*PLANS FOR THE CONSTRUCTION OF
SEDIMENT REMOVAL
FOR
VITRUVIAN PARK
TOWN OF ADDISON, TEXAS
PUBLIC WORKS #19-77*

VITRUVIAN PARK
 DREDGING
 TOWN OF ADDISON
 DALLAS COUNTY, TEXAS

revisions	date
1 ADDENDUM 3	2/20/2019

GROTTO CROSS SECTIONS					Sheet No. 20
design	drawn	checked	scale	date	NDM job number
NDM	NDM	NDM	NDM	2/20/19	18-005

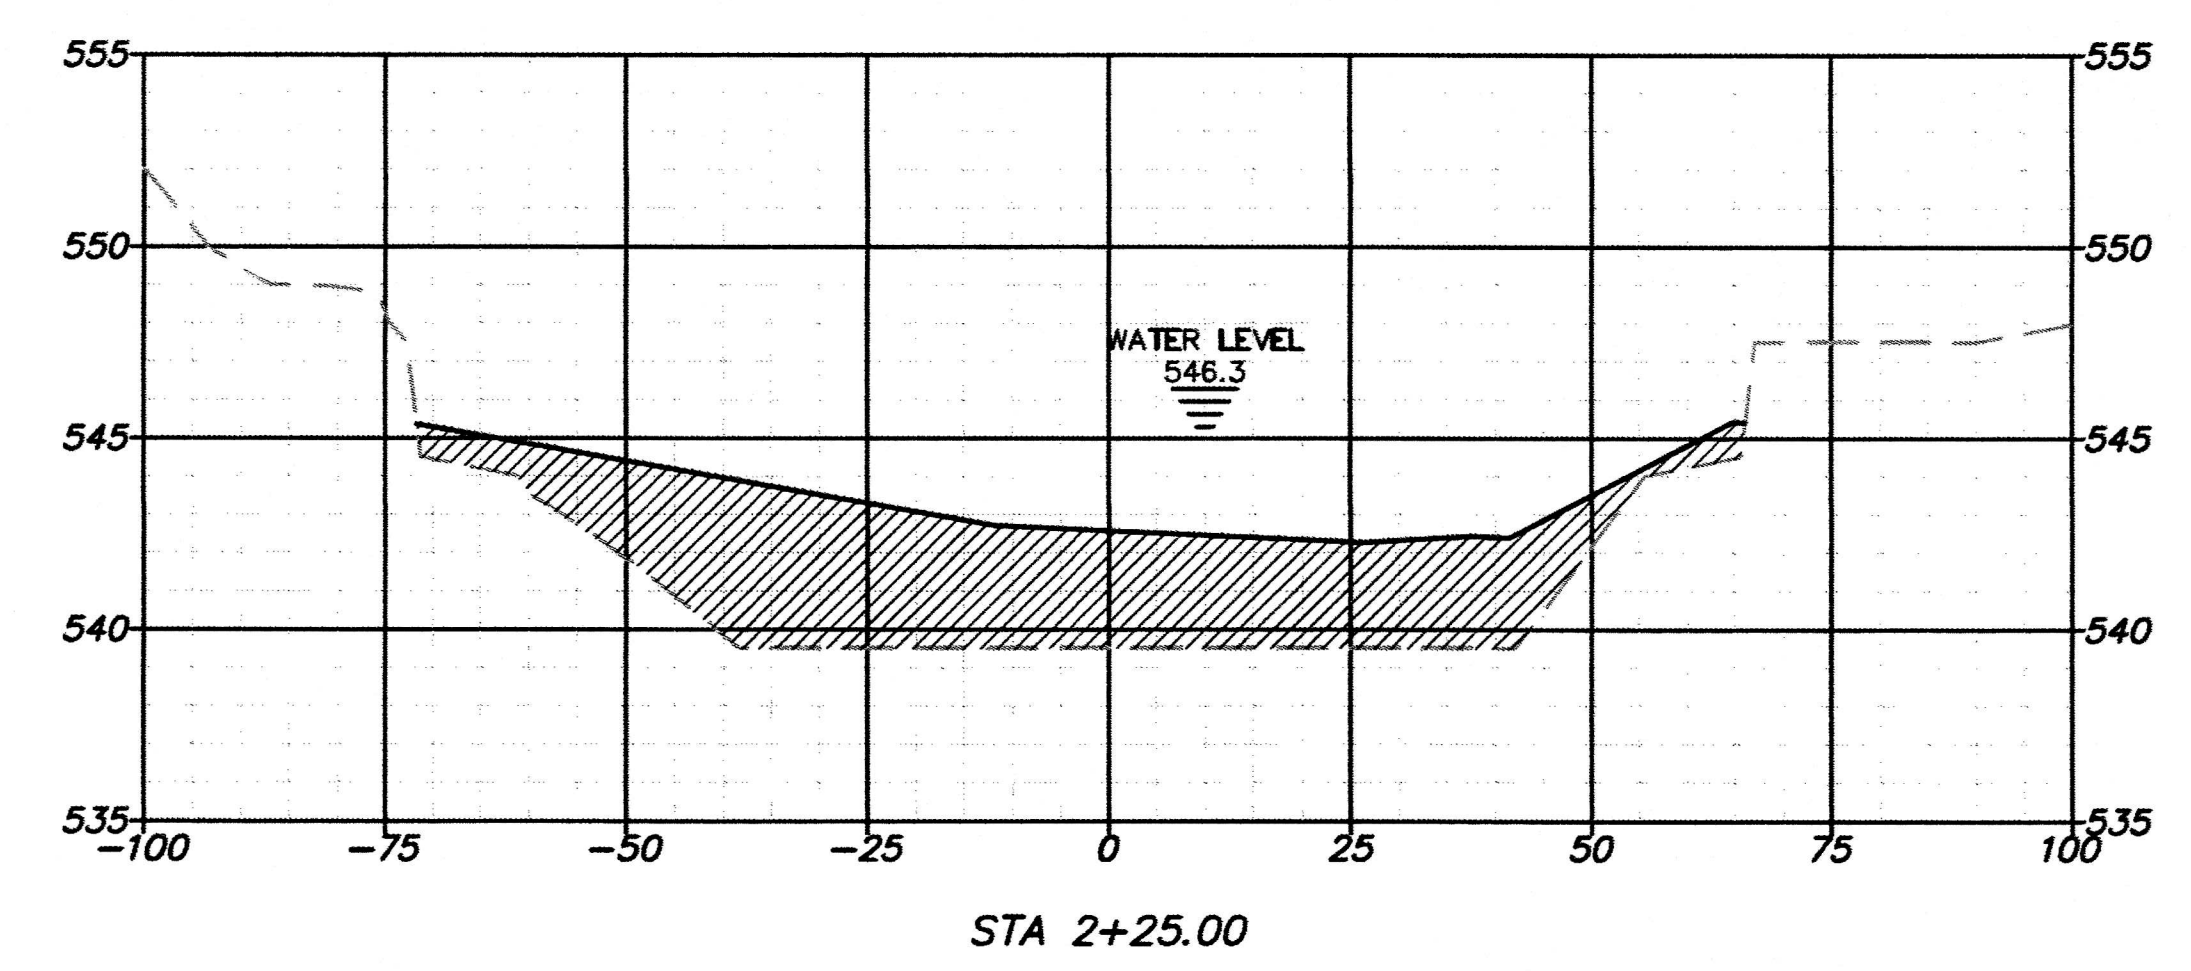
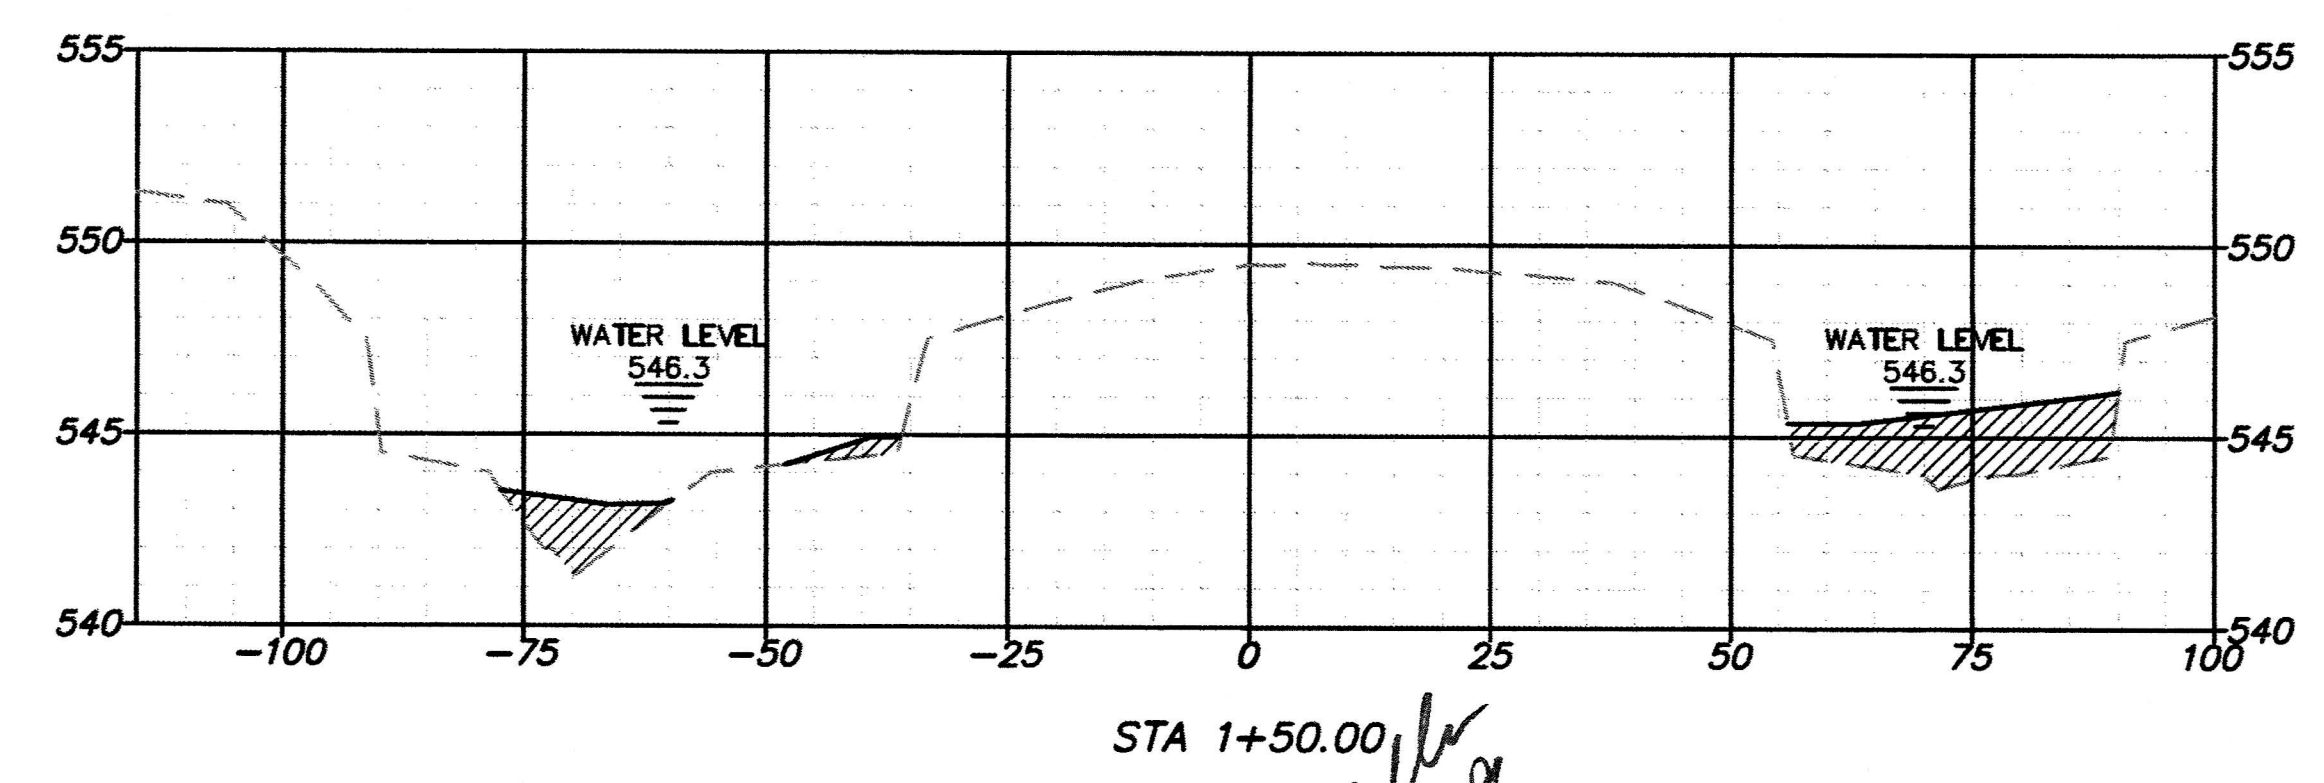
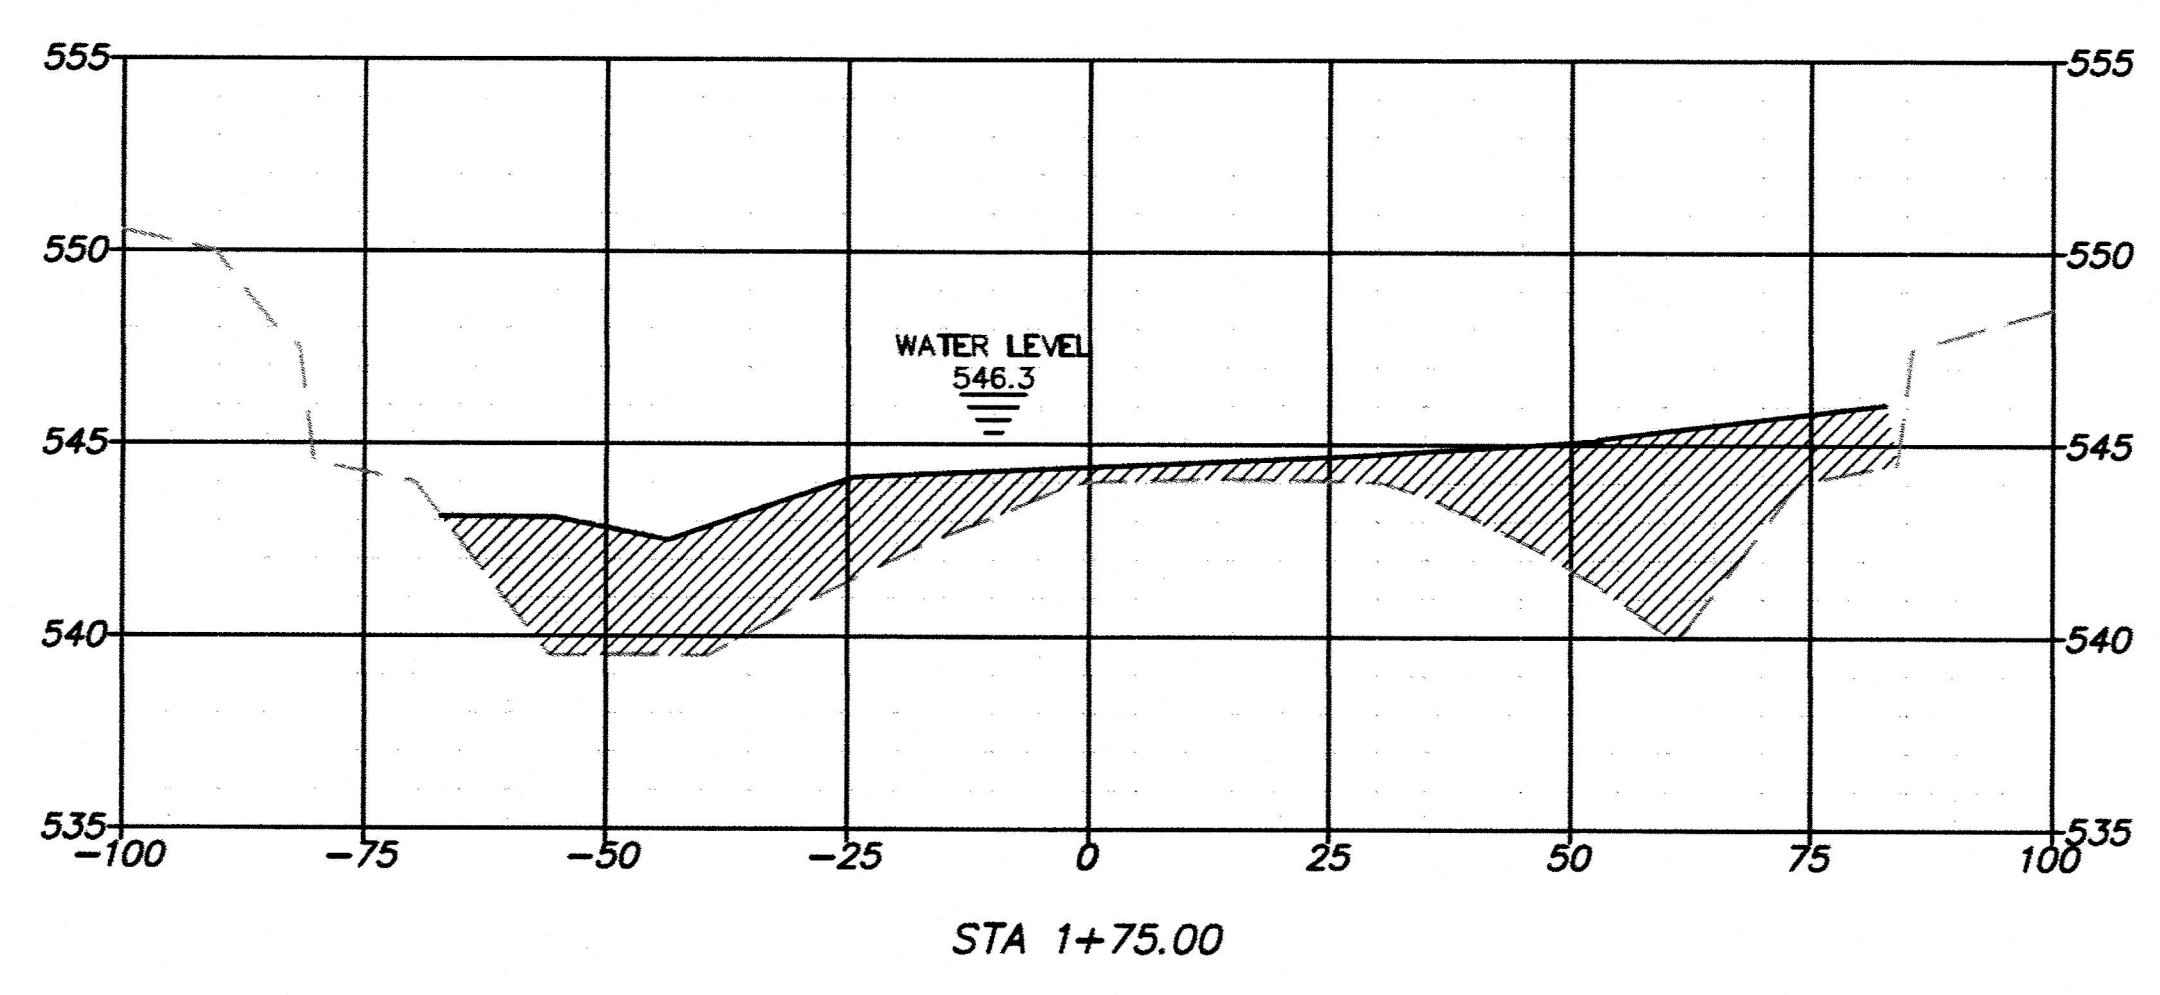
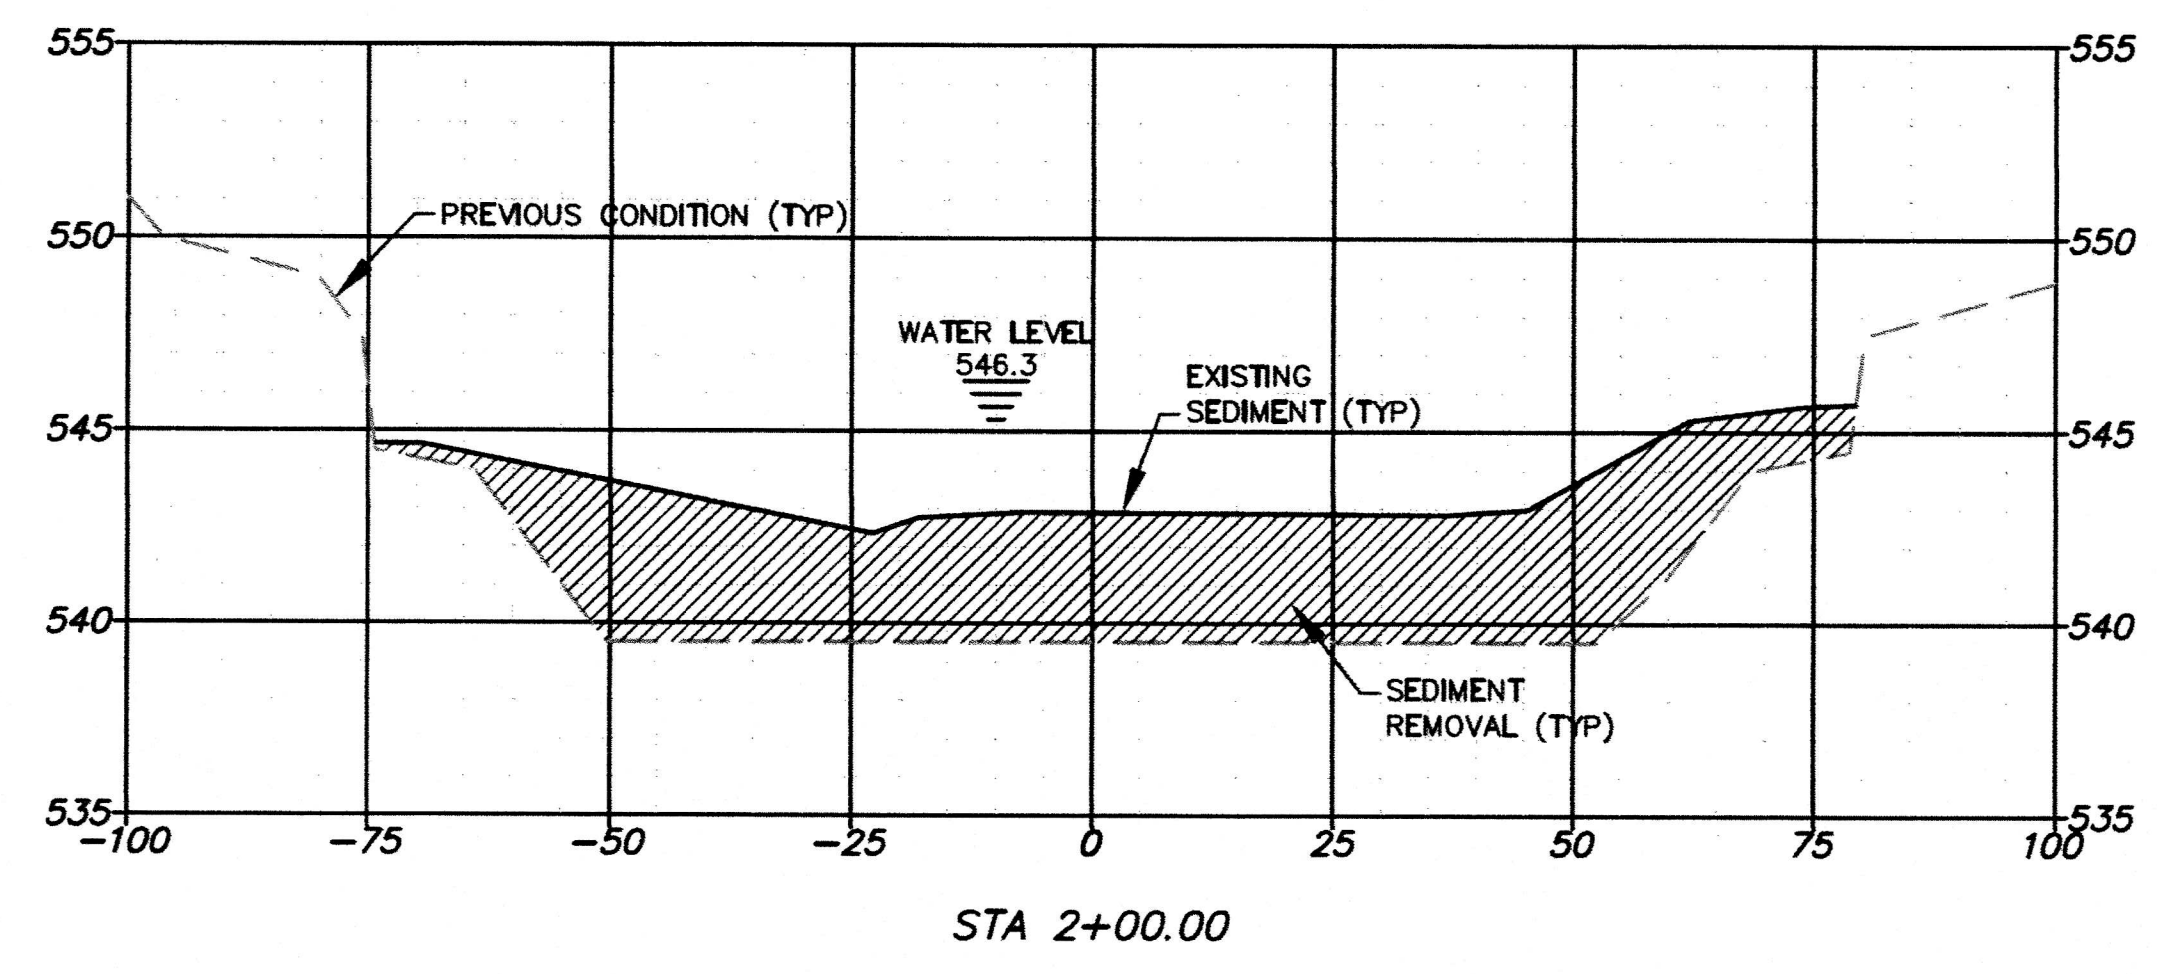
NOTE: WATER SURFACE ADDED BASED ON SURVEY OF 2/18/2019.
